## ***Interactive comment on “Biomass burning at Cape Grim: exploring photochemistry using multi-scale modelling” by Sarah J. Lawson et al.***

**Sarah J. Lawson et al.**

Received and published: 6 July 2017

**Fig. 1.** Figure 2 Base hourly diurnal emissions and revised Macarthur Fire Danger Index (FDI)-scale emissions generated using TAPM and CCAM meteorology

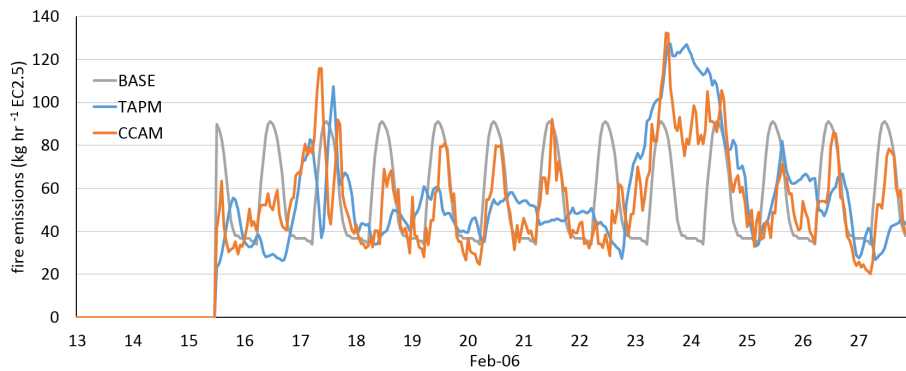
P8, L24: You don't define how you arrived at the "base" emissions shown in Figure 2, or why the total emissions (integral under the curves) is not the same in the base and the FDI-scaled emissions. We need more detail on what you are doing to calculate the emissions

>Thank you for pointing out this issue with the description and Figure 2. We have now updated Figure 2 to correctly represent the emission profiles for the "base" scenario and have replaced the "Revised" profile with the FDI-scale emissions generated using TAPM and CCAM meteorology. We note that the integral of each emission profile (thus the total mass of EC2.5 emitted) is now consistent. The text has also been updated to include more detail on how the emissions were calculated.

"The effect of wind speed on the fire behaviour and emissions in particularly important during the second BB event in which the winds ranged from 10 to 15 m s<sup>-1</sup>. This is evident from Figure 2 where hourly emission profiles based on an average diurnal FDI calculated by Meyer et al. (2008) (which peaks early afternoon) is compared with profiles based on hourly FDI generated by TAPM and CCAM meteorology. It can be seen that the use of the dynamic FDI approach during the BB2 period increases the BASE emissions by 70% for TAPM meteorology and by 45% for the CCAM meteorology. It is also notable that the use of the dynamic approach with TAPM meteorology leads to the peak emissions occurring overnight on the 24th Feb which is when the BASE emissions are at a minimum."

**Fig. 2.** Figure 6. Simulated CO using a) TAPM-CTM and b) CCAM-CTM, simulated BC using c) TAPM-CTM and d) CCAM-CTM, and simulated O3 using e) TAPM-CTM and f) CCAM-CTM. Coloured lines represent different MCE EF

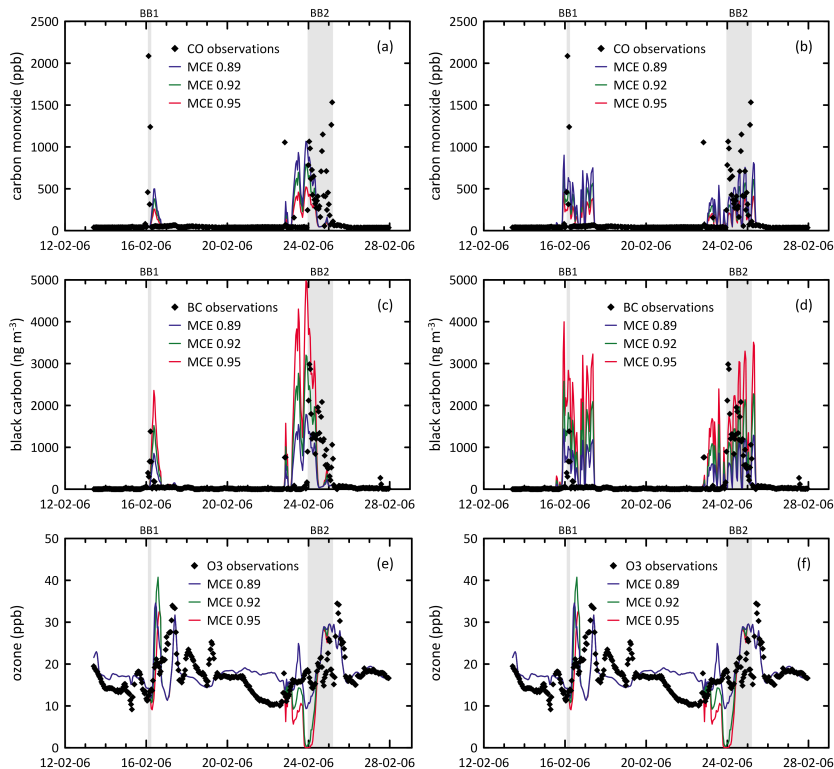
Figure 5: I'd suggest increasing the font size of all the text in this plot. It is difficult to read right now.

>as suggested font size of (now Fig 6) has been increased. This was also requested by Reviewer 3.

**Fig. 3.** Figure 8 Simulated spatial variability using TAPM-CTM with MCE=0.89 showing a) time series of CO over two weeks of fire (BB1 and BB2 shown), b) the observed and modelled cumulative concentration of C

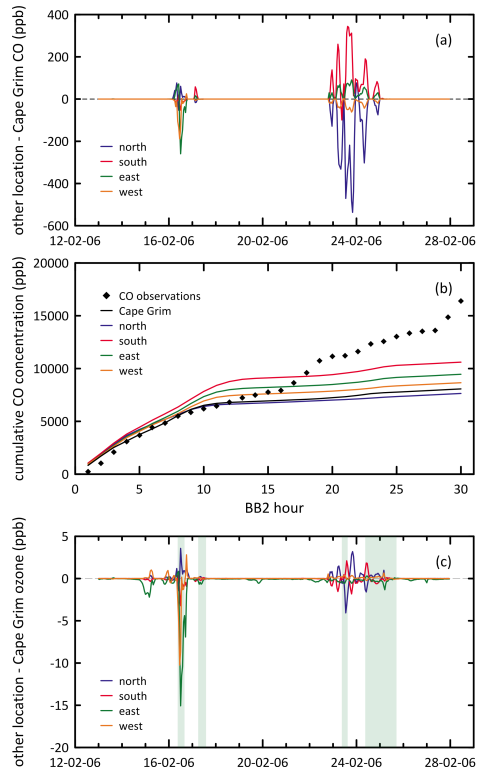
Figure 6c: I'd suggest adding vertical lines or bands showing the four modeled O3 peaks on this figure, so we can see how the peaks are affected by the presented differences. >As suggested this figure (now Fig 8c) has been modified so that these four modelled O3 peaks are shaded.
